Access Compliance Report

Public Rights-of-Way

Intersection ID: 7563	Main Street: WALDON_RD	Cross Street: SHARPES_CR	Location: SE
ADA ID: B5B580D03EA7	Ramp Type: Perp	Initial Pass/Fail: Fail	Overall Compliance: No
Severity Score: 8.75			
Codes/Mitigation Info/Possible Solution		Field Measurements/Component Compliance

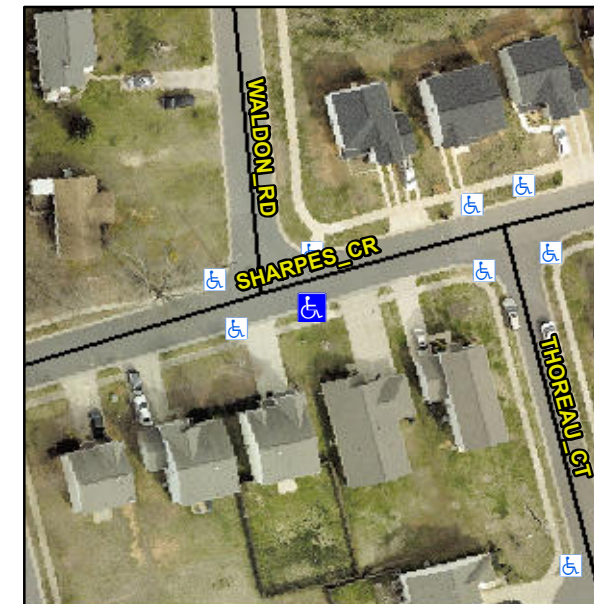
Not Found, R304.5.1

Compliance	Description	Data	Compliance	Description	Data
N/A	Ramp Length (in)	48.5	Yes	Ramp Slope (%)	5.6
No	Ramp Width (in)	47.5	Yes	Ramp XSlope (%)	1.5
N/A	Flare Type LT	N/A	N/A	Flare Type RT	N/A
N/A	Flare Slope LT (%)	N/A	N/A	Flare Slope RT (%)	N/A
N/A	Flare Traversable LT?	N/A	N/A	Flare Traversable RT?	N/A
N/A	Landing Length (in)	N/A	N/A	DWS Provided?	N/A
N/A	Landing Width (in)	N/A	N/A	DWS Contrast?	N/A
N/A	Landing Slope (%)	N/A	N/A	DWS Length (in)	N/A
N/A	Landing X Slope (%)	N/A	N/A	DWS Full Width?	N/A
N/A	Landing Curb? (Y/N)	N/A	N/A	DWS Offset (in)	N/A
N/A	Shared Landing?	N/A			
N/A	Gutter Ponding?	N/A	N/A	Gutter Slope (%)	N/A
N/A	Gutter Lip Ht (in)	N/A	N/A	Gutter X Slope (%)	N/A
N/A	Painted X Walk1?	No	N/A	Painted X Walk2?	N/A
	X Walk 1 Direction	To N		X Walk 2 Direction	N/A
N/A	X Walk 1 Width (in)	N/A	N/A	X Walk 2 Width (in)	N/A
	X Walk 1 Slope (%)	8.1		X Walk 2 Slope (%)	N/A
	X Walk 1 X Slope (%)	1.9		X Walk 2 X Slope (%)	N/A

Remove & Replace Entire Ramp.
